Seismic Walkdown Checklist (SWC)

Equipment ID No: Q2N23FI3229CB Equip. Class: 18

Equipment Description FEEDWATER INTAKE FLOW INDICATION

Q2N13F1329CB

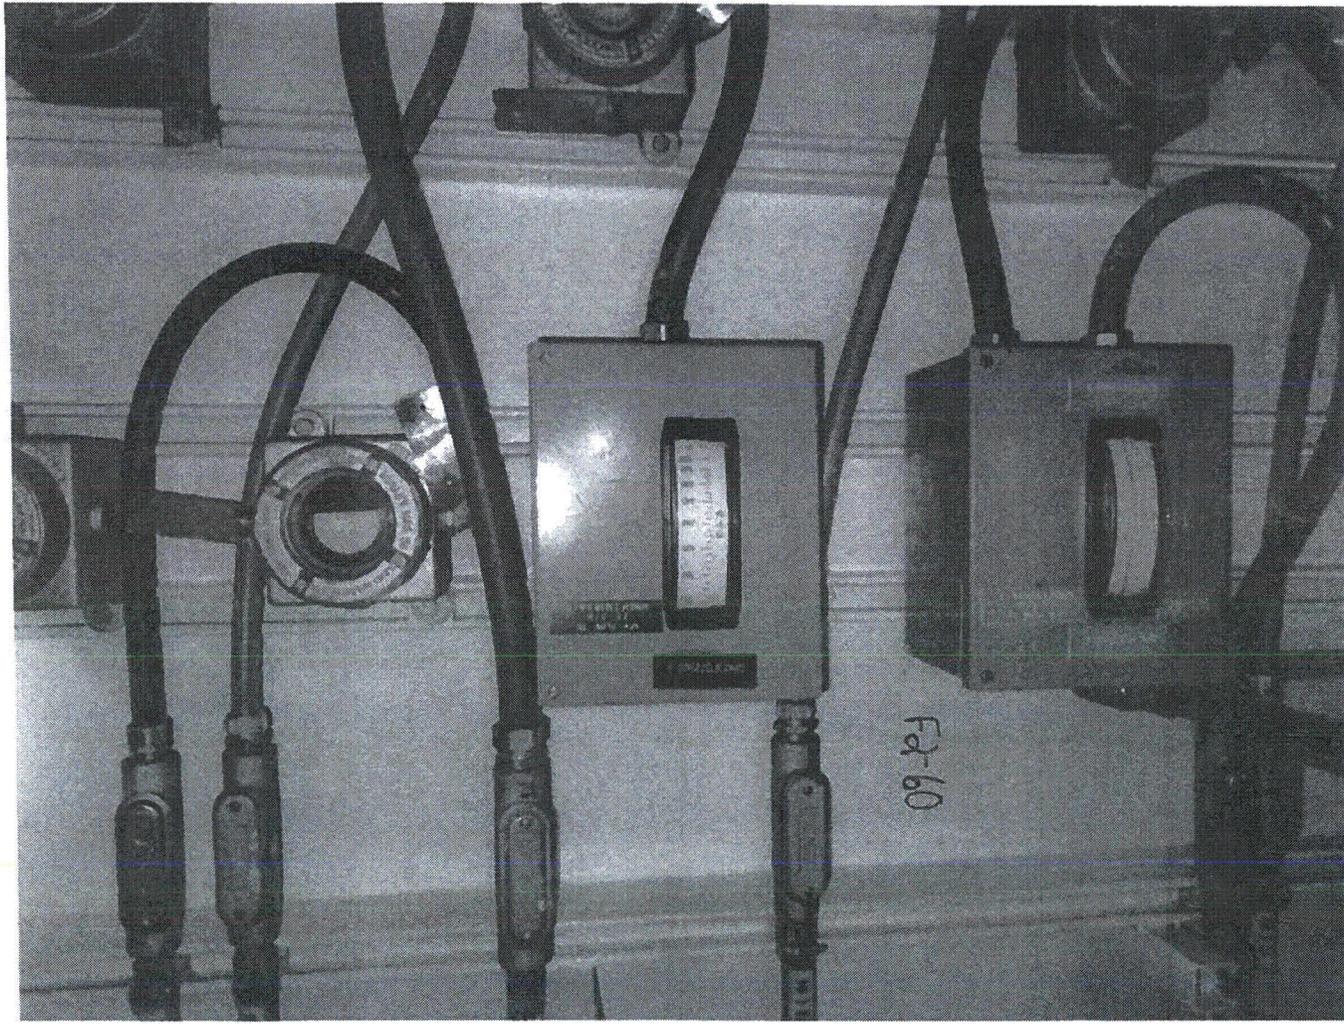
Small Flex conduit touching or very close, any impact would be minimal, judged okay.

F2-67

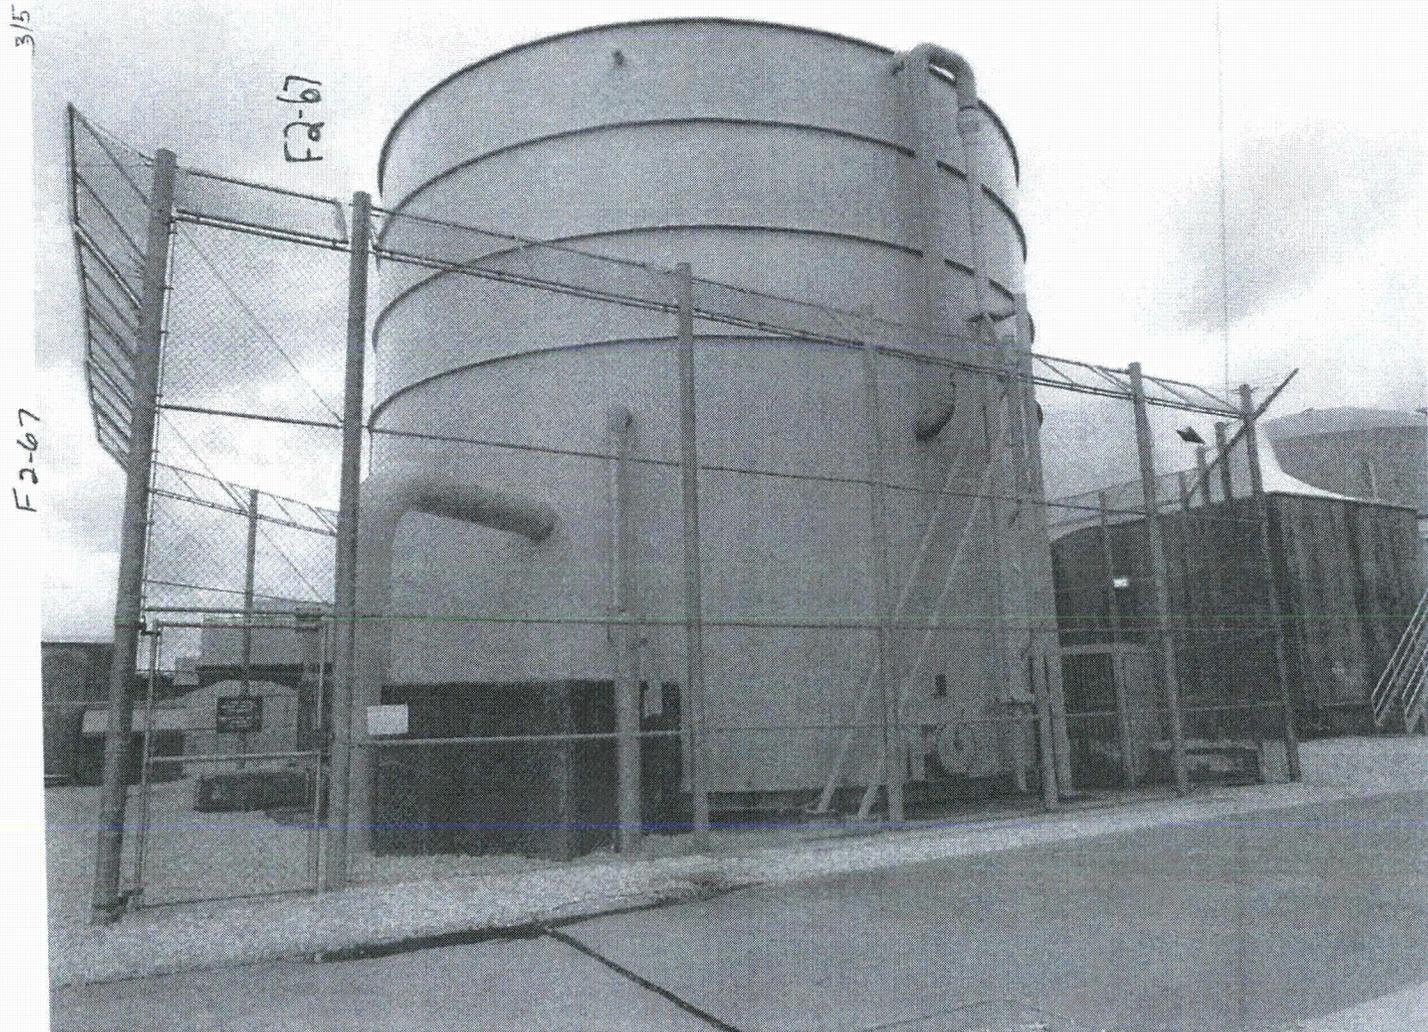
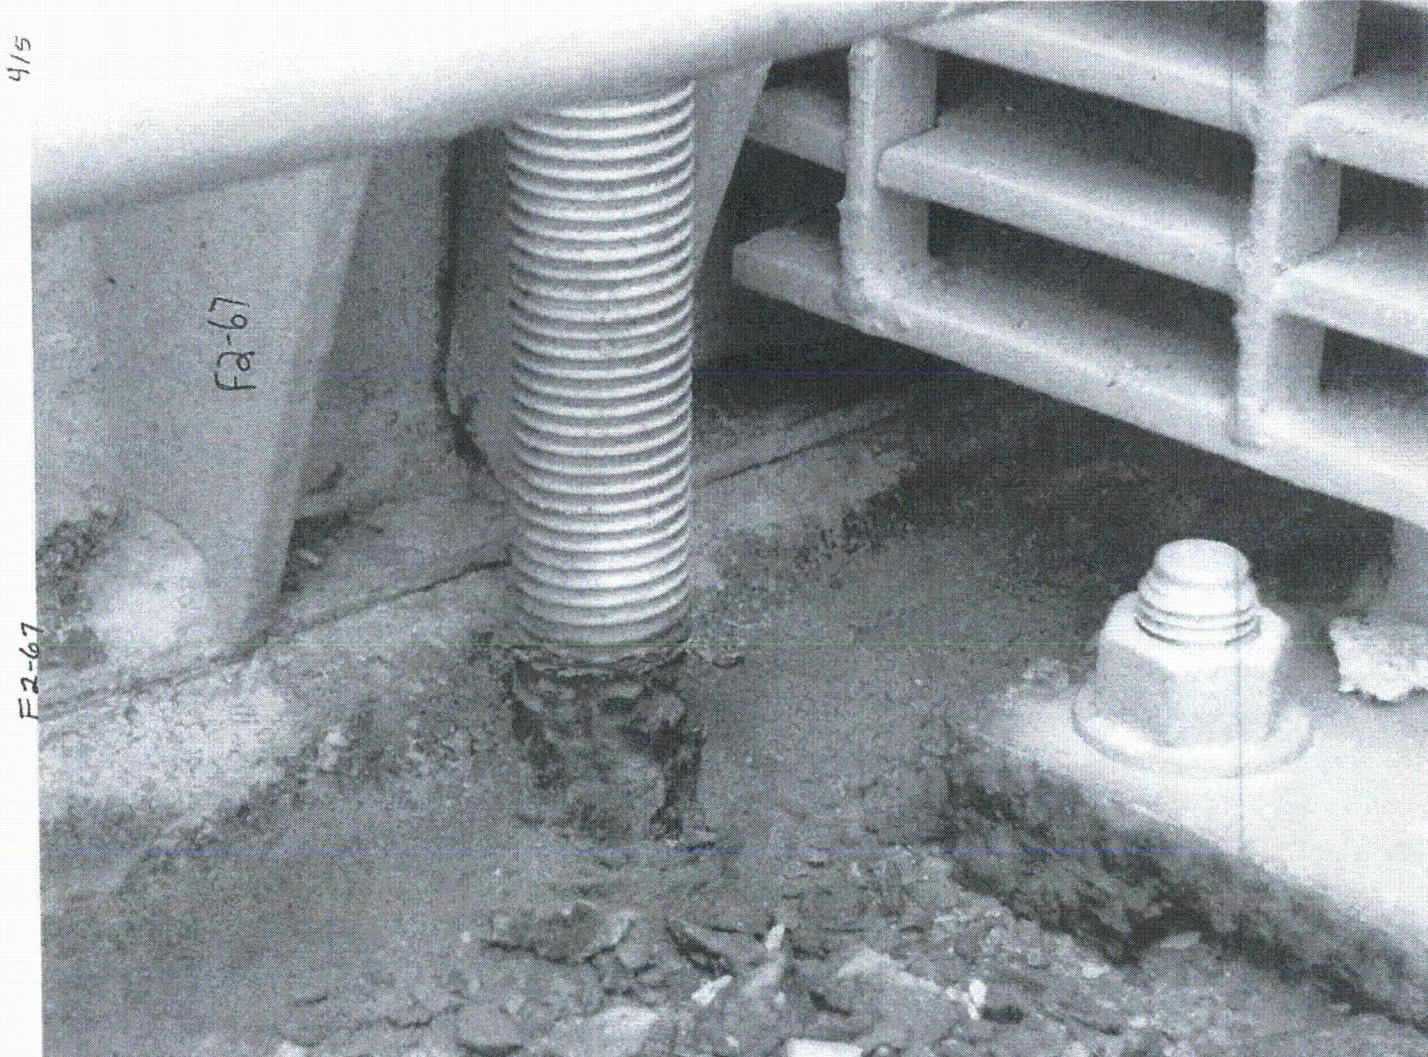
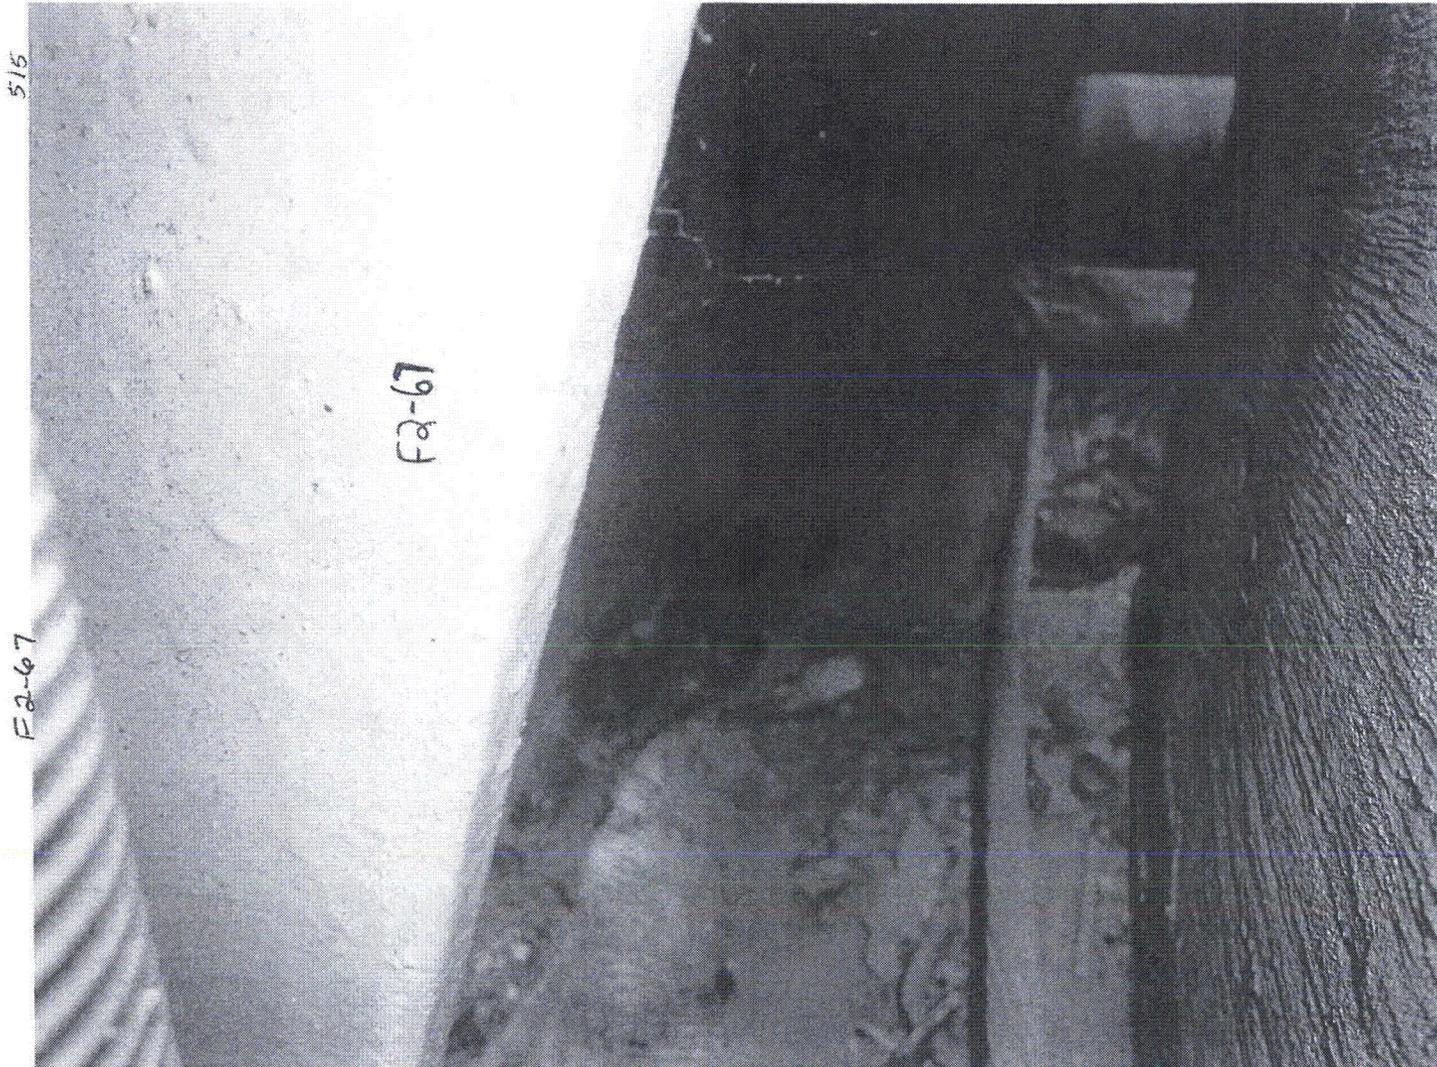
There is some corrosion on bolts but appears to be only slight loss of materials. Bolts on West side by Manhole appear to have most corrosion. Also slight rust on Tank Flange. All judged to be seismically OKAY.

CR 507645 written to clean and paint bolts.

F2-69

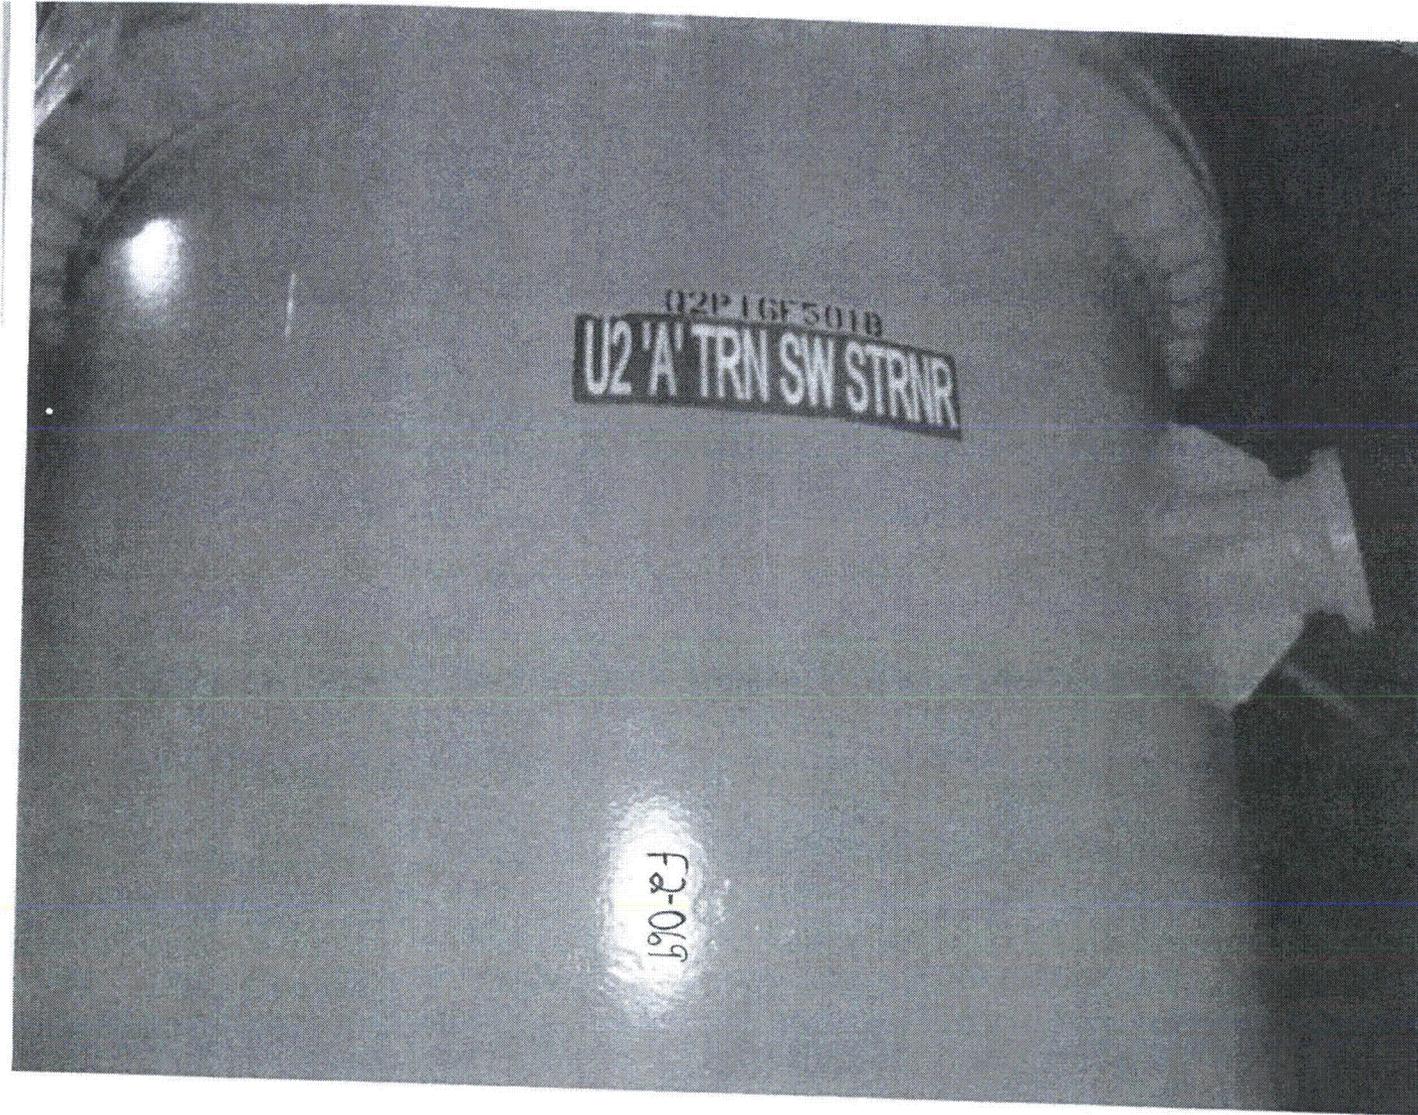
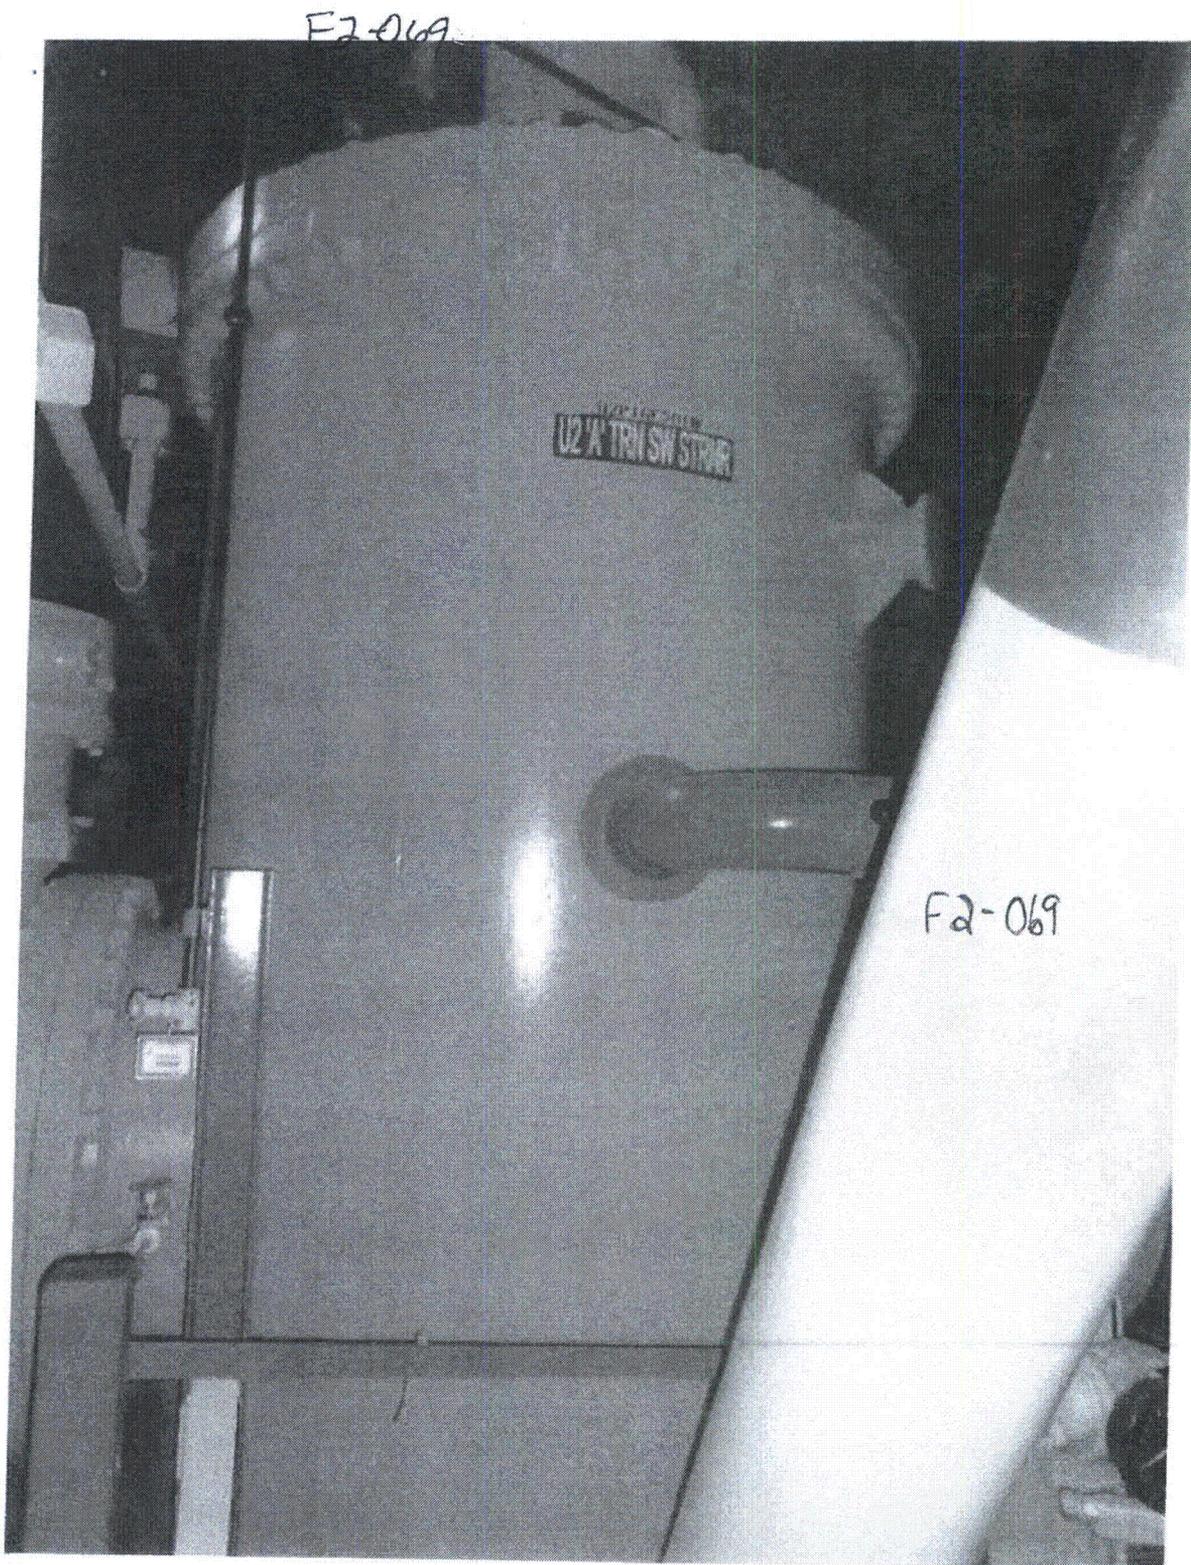
corrosion on 3/4 bolts due to standing water in the area and water leaks coming from top of strainer.

Area walk-by is in folder F1-119, Equipment QSW41C513D.
CR 509270 was written to document the corrosion.
